**CORK COUNTY COUNCIL**  
**WESTERN DIVISION**  
**WATER SERVICES**

**APPLICATION FOR WASTE**  
**WATER DISCHARGE LICENCE**  
**DUNMANWAY**

**REPLY TO REGULATION 18(3)(b)**  
**NOTICE**

**Re: D0160-01 - Dunmanway Waste Water Discharge Licence Application**  
**- Reply to Notice in accordance with Regulation 18(3) of the Waste Water**  
**Discharge (Authorisation) Regulations 2007**

DRAWING TITLE: CORK COUNTY COUNCIL  
 ATTACHMENT C.2 - LOCATION OF ALL DISCHARGE POINTS  
 SCALE: 1:10000 JOB NO: DRAWING NO:  
 DATE: 5/6/09 DRAWN BY: JH 2846 DUNMANWAY\_C2\_21R

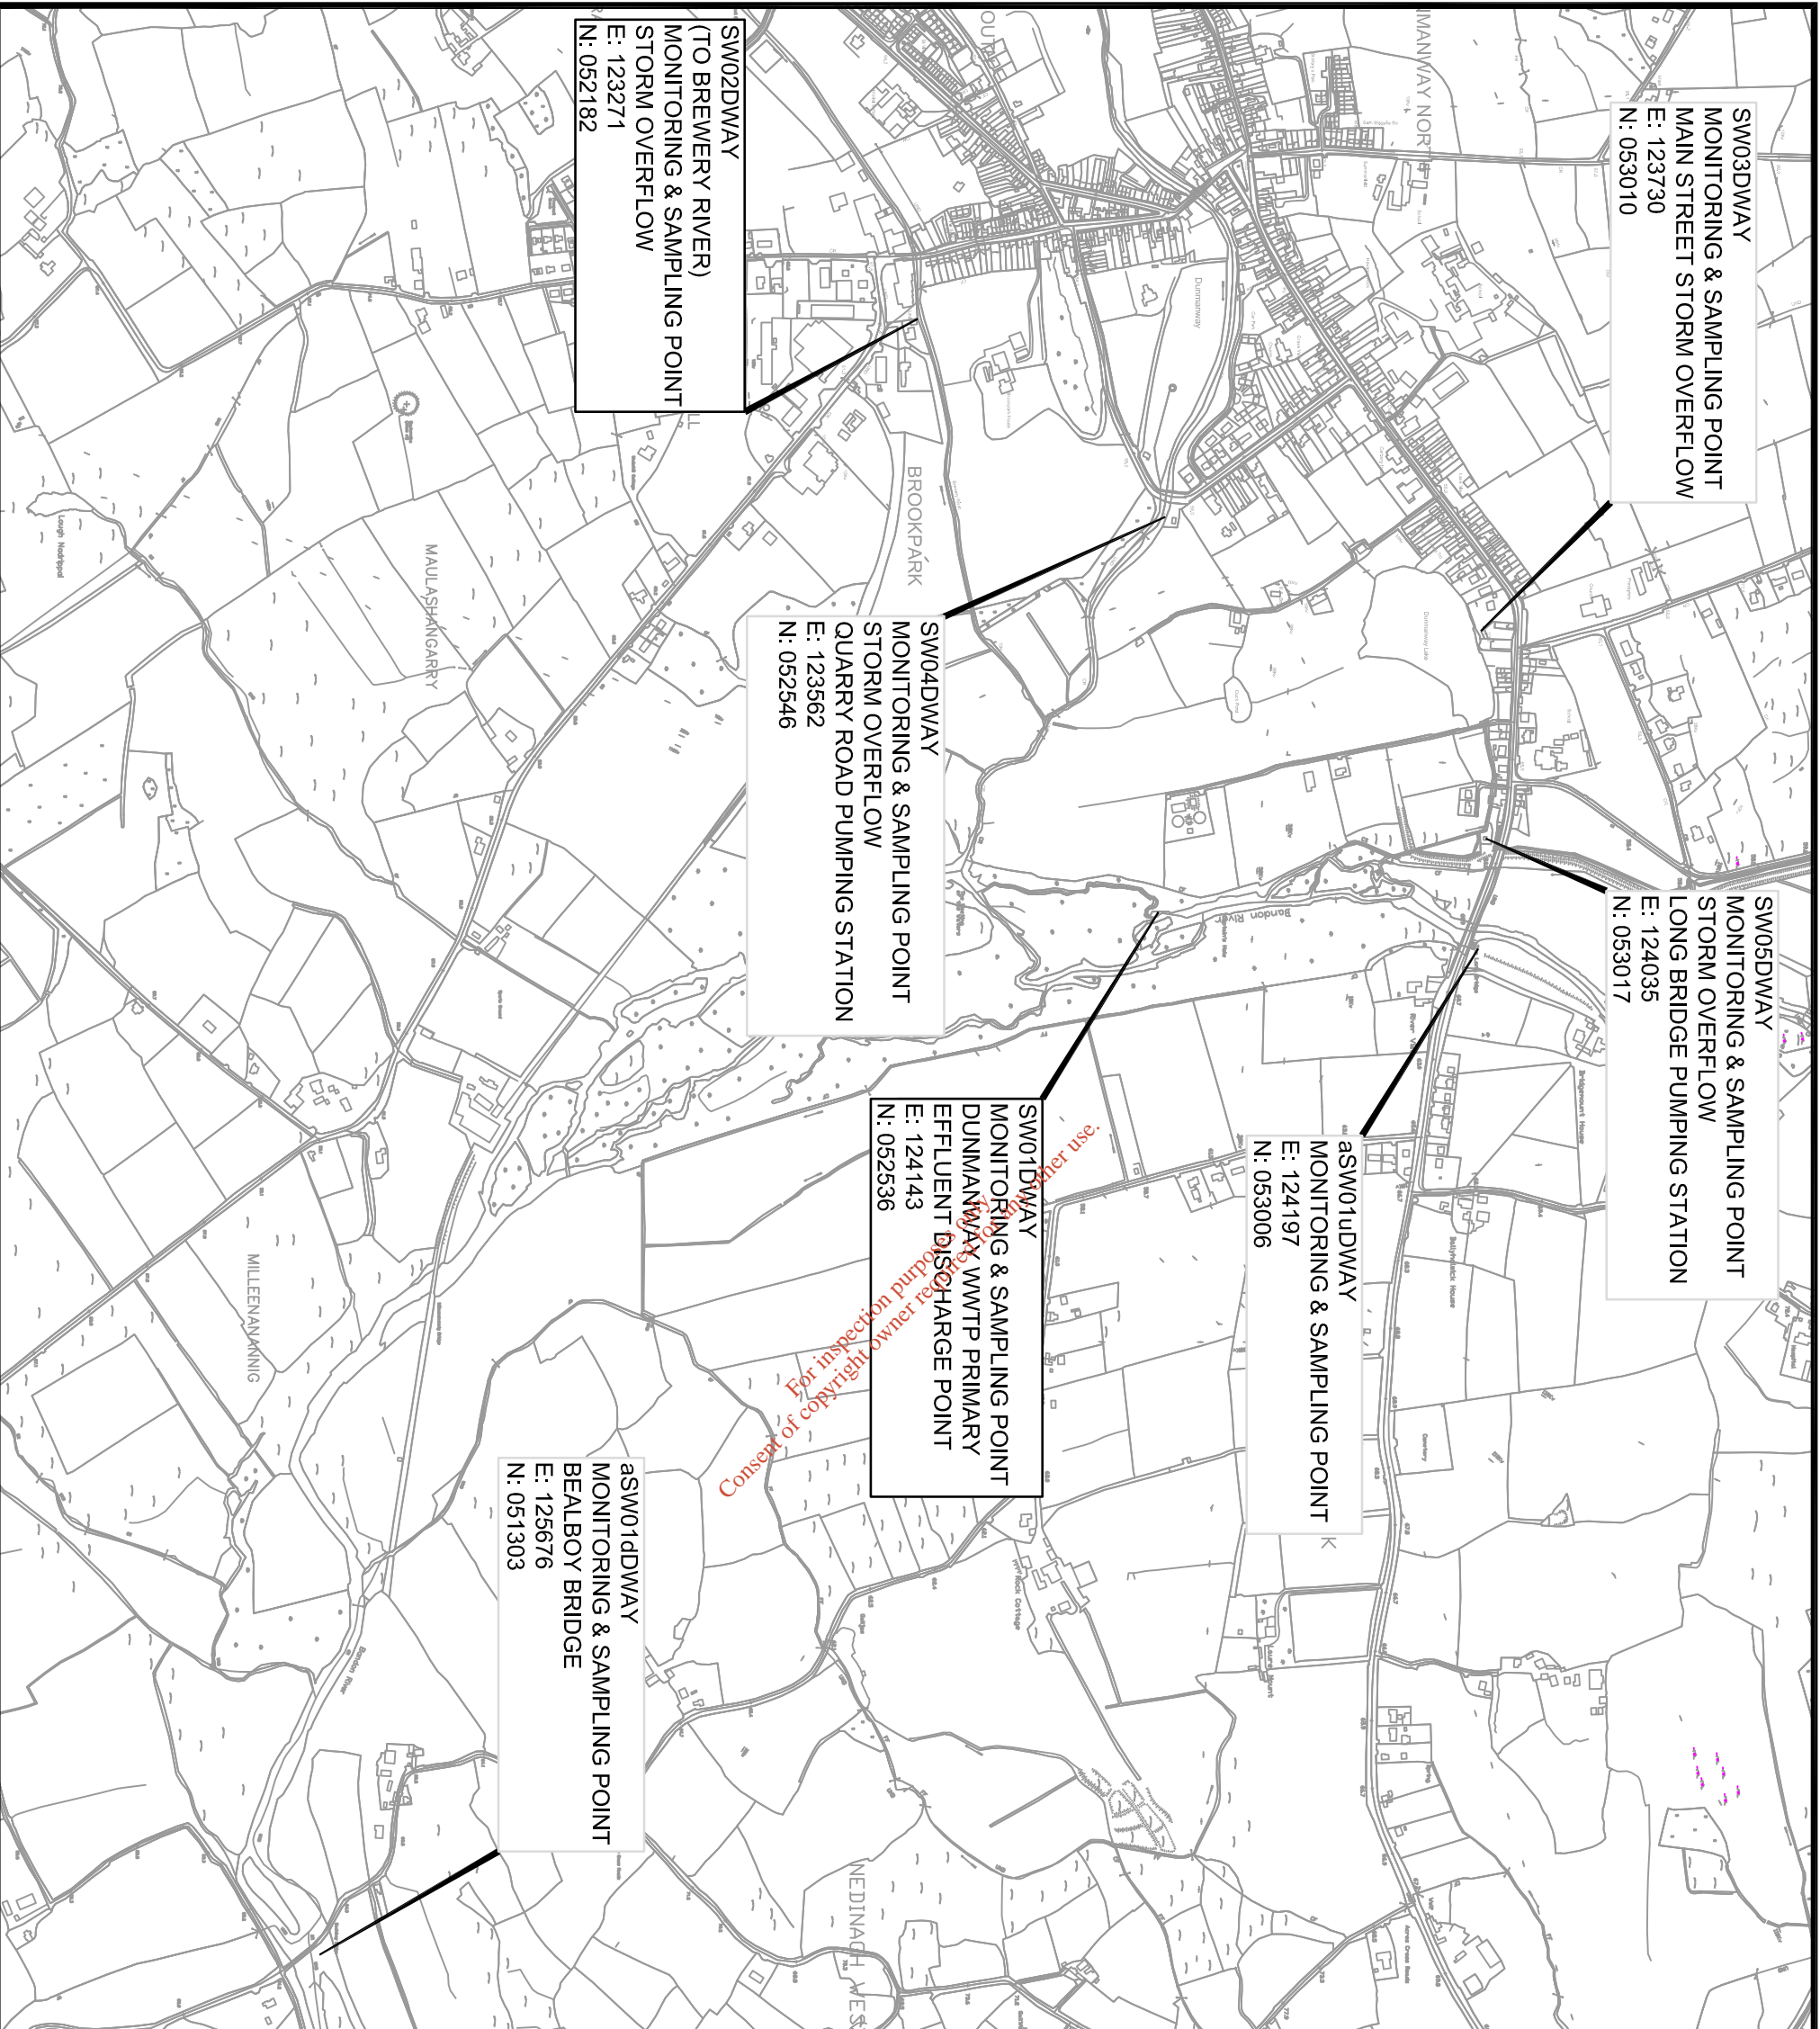
- ii. The discharges from the Long Bridge and Quarry Road Pumping Stations are emergency overflows and storm overflows. As such they are not secondary discharge points. Attached please find drawing nos. C2\_21R and E2\_22R amended accordingly. Drawing nos. B4\_13, B4\_14, B4\_15, B4\_16 and B4\_17 denoting these secondary discharge points are to be excluded and replaced by drawing nos. B5\_14, B5\_15, B5\_16, B5\_17 and B5\_18R denoting storm overflow discharges. Attached also please find amended Sections B.3, B.4, B.5 of Application and tables E1.(i) and D.1 and D.2.
